TIMARU DISTRICT COUNCIL HEARING
COMMITTEE

STATEMENT OF EVIDENCE BY KEVIN THOMAS KEMP

Attachment A: Response to Growth Submissions

Sub: 231	T Blackler	10 Burke Street, Pleasant Point
----------	------------	---------------------------------

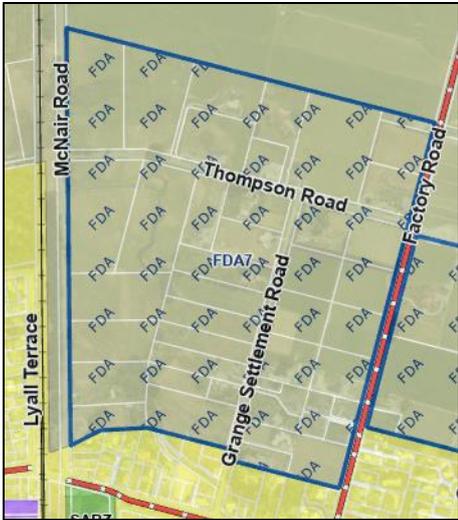
There is no mechanism tying this to the rezoning sought in the submission.	
Comment:	<ul style="list-style-type: none"> • Insufficient detail supplied to support the rezoning. • More detailed structure planning required to support rezoning. • Request for rezoning to General Res should be rejected. <p>A consideration of each 3W matter is as follows:</p> <p>Stormwater</p> <p>The site is outside the Pleasant Point Stormwater Management Area, although bordered on 3 sides by the stormwater management area. The site would require consent from the Regional Council for Stormwater Discharge and development within Waterways.</p> <p>More detail on potential flood risk is required.</p> <p>Wastewater</p> <p>Comments provided about wastewater servicing but no detail. Impact on the network is required to be modelled.</p> <p>Water</p> <p>Water service extensions required. Impact on the network is required to be modelled.</p> <p>No funding exists to service these sites within the LTP.</p>

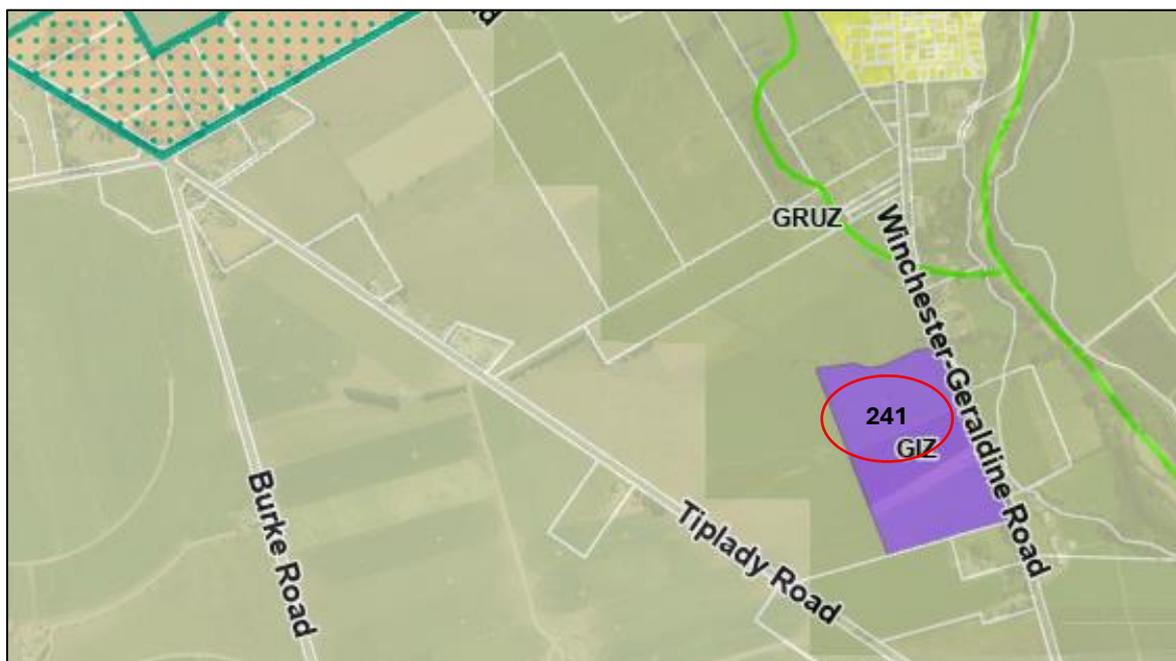
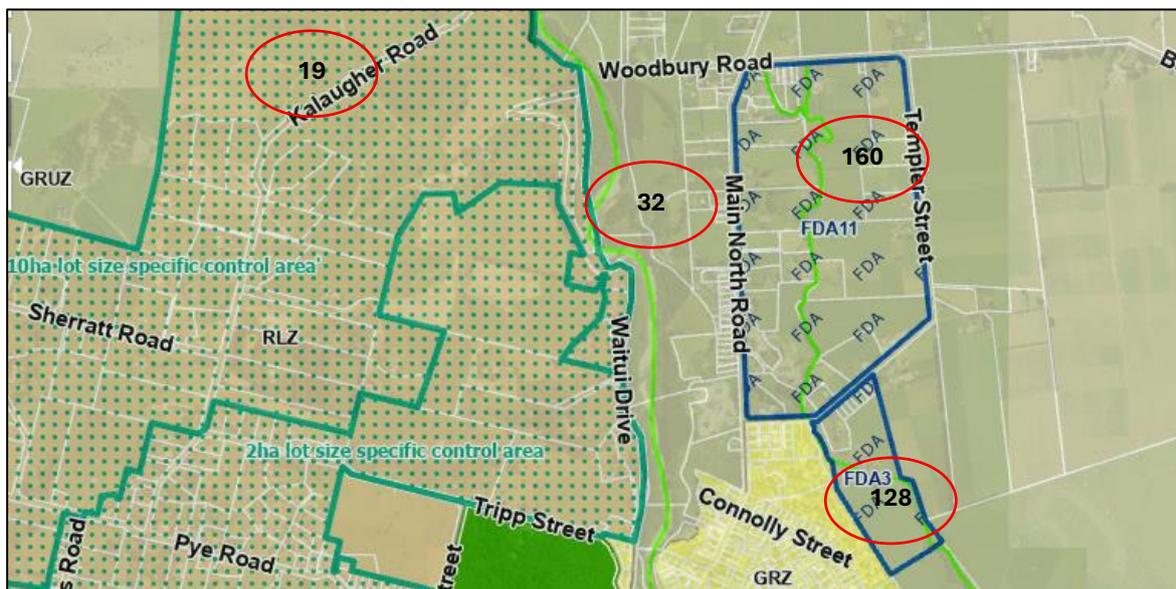
Comment:	<p>The submission seeks to simply support the notified TPDP provisions.</p> <p>As noted by the submitter, extensive work needs to occur in relation to the serviceability of the area. The submission does not seek to change the FDA approach, so there is nothing additional to comment on other than noting the servicing constraints may impact on the achievability of a re-zoning through the FDA process.</p> <p>Recommendation is that the FDA approach be maintained. It should be noted that the infrastructure constraints may impact the feasibility of achieving a successful development moving forward, in which case the density would largely remain as currently present.</p>

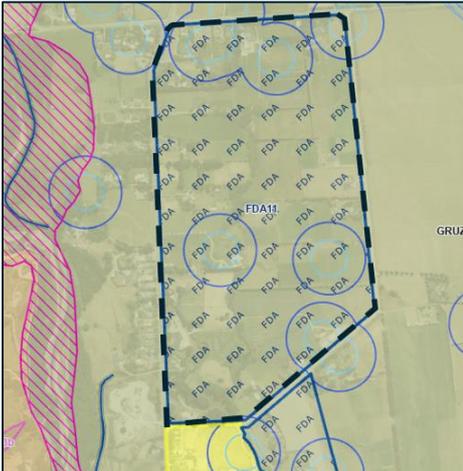
Comment:	<p>The submitter does not demonstrate how the site will be serviced. Considering the servicing of a single site in isolation is bad practice and may impact on the wider area into the future. No examples of what development of the site may look like, no impacts of the topography of the site on how it will be serviced. Private service extensions in such a linear and disjointed manner to service a limited number of rural lifestyle allotments (and the cost share so that costs do not fall on the wider ratepayer base) is a poor network outcome.</p> <p>There is no funding provided in the LTP associated with servicing this block, in isolation or in combination with proximate areas. Any funding</p>

No modelling, funding or analysis has been provided to the Council demonstrating how this area would be effectively and efficiently serviced for reticulated Water Supply to accommodate the submission and associated rezoning to Rural Lifestyle Zone.

No modelling, funding or analysis has been provided to the Council demonstrating how this area would be effectively and efficiently serviced for reticulated Sewer disposal to accommodate the submission and associated rezoning to Rural Lifestyle Zone.

Geraldine infrastructure is unable to accommodate the disposal of blackwater if a connection or on-site disposal was not achievable, meaning waste from an on-site holding tank needs to be transported to Timaru for disposal.

The site is outside TDCs Current Stormwater Management Area. A discharge consent would be required from Environment Canterbury.

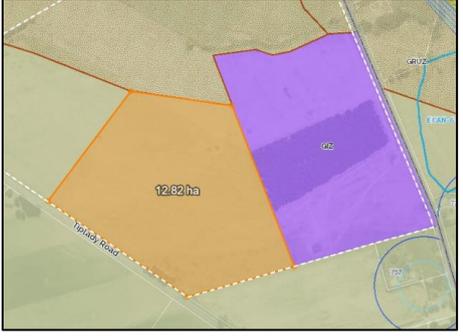
<p>Comment:</p>	<p>The DAP process is intended to support coherent development. Further ad-hoc development without any controls will result in additional constraints of reticulated services being provided into the future. Re-zoning to 5000m² minimum without a DAP process and a certain approach to the provision of water and wastewater reticulation is not supported.</p> <p>The existing disjointed nature of FDA 11 could lead to the establishment of inefficient and costly infrastructure to service sites in an ad-hoc manner. A cohesive landowner funded wastewater network extension (and associated infrastructure) would be challenged by the extent of</p>

There is no funding identified in the LTP to provide or contribute towards reticulated wastewater infrastructure to service the area.

The impact of on-site blackwater tanks should be further investigated because if an on-site solution via ECan is not achievable the waste inevitably ends up at a Council facility which still results in effects on Council's infrastructure. Experience suggests most people will seek a blackwater holding tank on-site rather than composting toilets. Geraldine infrastructure is unable to accommodate the disposal of blackwater, meaning waste needs to be transported to Timaru for disposal.

The Te Moana scheme is for rural uses and the dispersal over residential sized lots is not anticipated. Te Moana Water Scheme Policy would apply for new connections.

Lacks clarity of yield and the like over the entire FDA. The size of lots will impact the best way to service water if possible. An assessment of the impact of existing on-site wastewater disposal on any surrounding drinking water bores (if any).

How an area wide network will be installed is not addressed and should be considered to understand costs and maintenance requirements moving forward.

At 5000m² density the possible demand on the Te Moana – Geraldine Flat water scheme is significant and would require further modelling to confirm capacity. With the existing property fragmentation, 2Ha lot size minimums would allow for approximately an additional 6 allotments. The Te Moana – Geraldine Flat water scheme can accommodate this increase in demand.

No information provided to assess. The land area is outside the Geraldine Stormwater Management Area. Any requirement for ECAN consenting would be at the developers cost and should be completed in an integrated manner across the whole of the site.

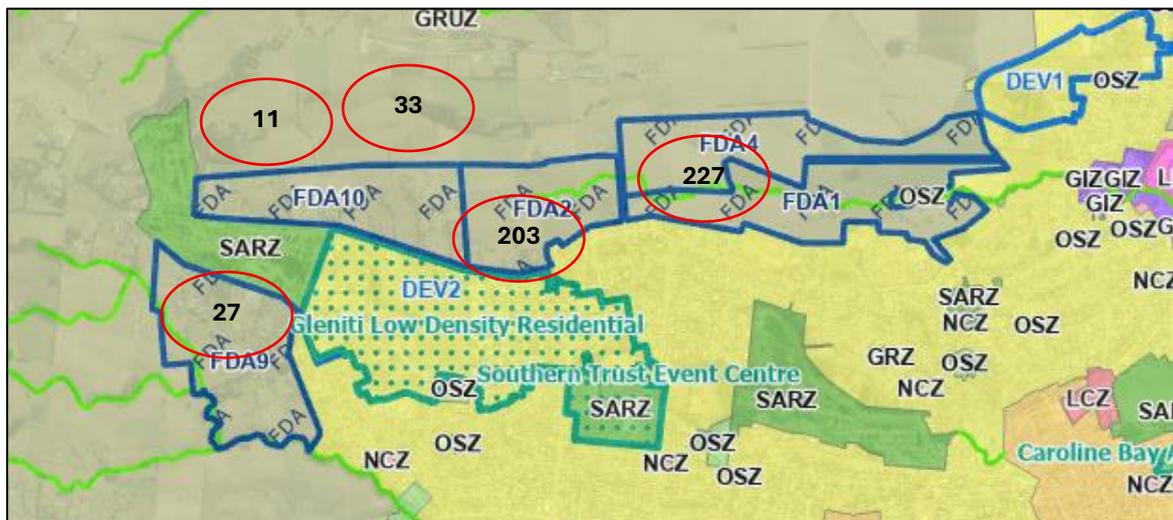
Comment:	<p>No technical information has been provided. It is noted that a request to Council for confirmation of servicing was made. Council is unable to provide confirmation of servicing when there is uncertainty in relation to design parameters such as design and yield.</p> <p>The submitter has not demonstrated how the servicing of the site will occur. Extensions are likely achievable but would need detailed modelling to fully understand the implications on Council's existing assets. Rezoning will simply defer this assessment to the time of a subdivision consent application which creates uncertainty as to the outcome for Council and the submitter. In the absence of design information, the submission should be rejected.</p> <p>Wastewater</p> <p>No information is provided as to certainty of intended yield or location of proposed services. Upgrades to existing infrastructure will likely be required with costs to be met by the developer. No funding exists in the LTP to support this development.</p> <p>Water</p> <p>No information is provided as to the certainty of intended yield or location of proposed services. Extensions to the existing network will be required. The applicant will need to meet the cost of any network upgrades. No funding exists in the LTP to support this development.</p> <p>Stormwater</p>

<p>No information is provided as to the certainty of intended design (noting that 100 allotments contained in the submission package does not appear to take into account site context, geotechnical and flood management, or reserve requirements) or location of the proposed services. The site is adjacent to a sensitive environment and will require design to manage stormwater which would likely constrain yield. This will also require compliance with requirements of Environment Canterbury. No funding in the LTP exists to support this development.</p>
--	---
